FINISH PLAN AND DETAILS

**MISSOURI SOYBEAN INNOVATION CENTER
 NEW OFFICE BUILDING**
 734 S. COUNTRY CLUB DRIVE
 JEFFERSON CITY, MISSOURI

A901

10/4/18- ADDENDUM NO. 1

G2 FINISH FLOOR PLAN- LEVEL 1
 SCALE: 1/8" = 1'-0"
 True North Project North

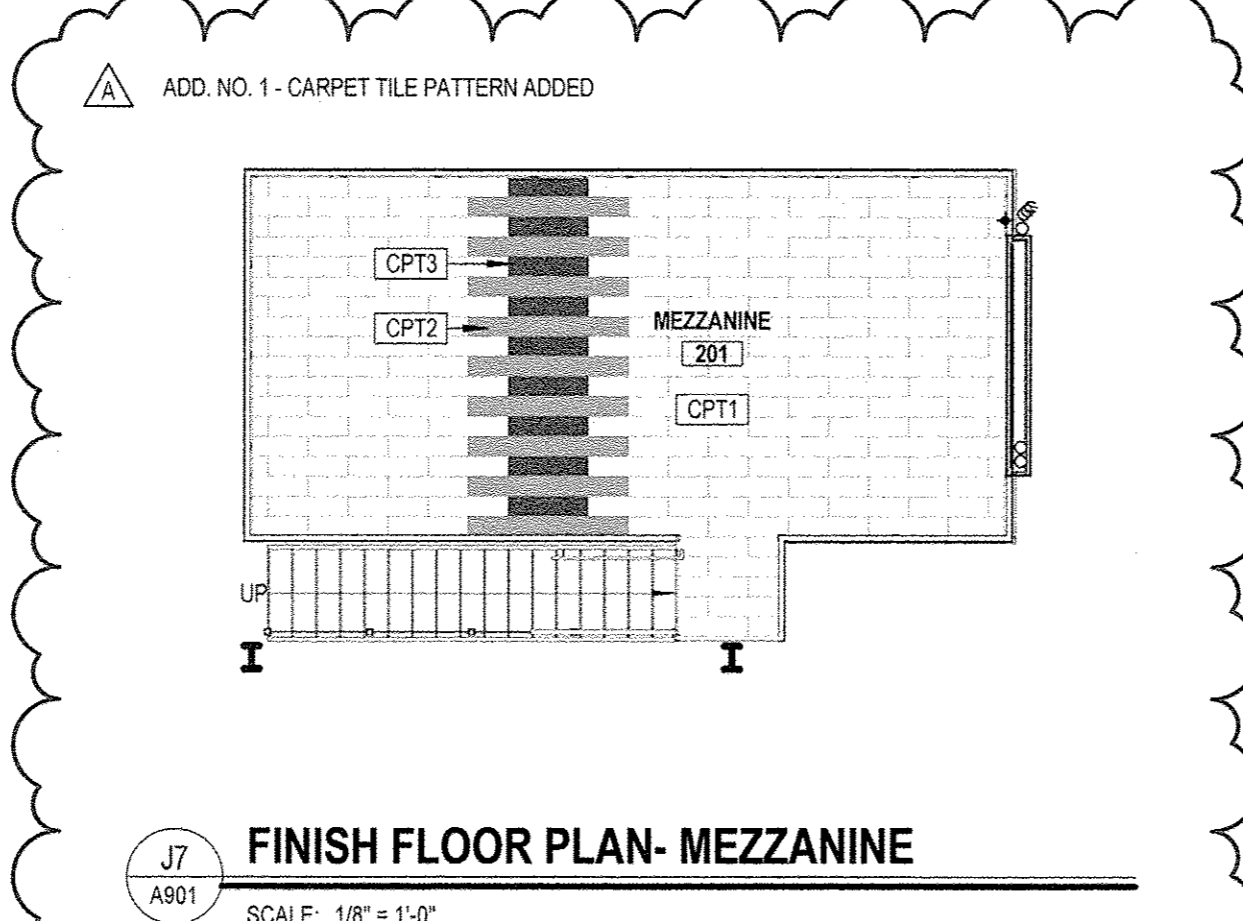
ADD. NO. 1 - CARPET TILE PATTERN ADDED
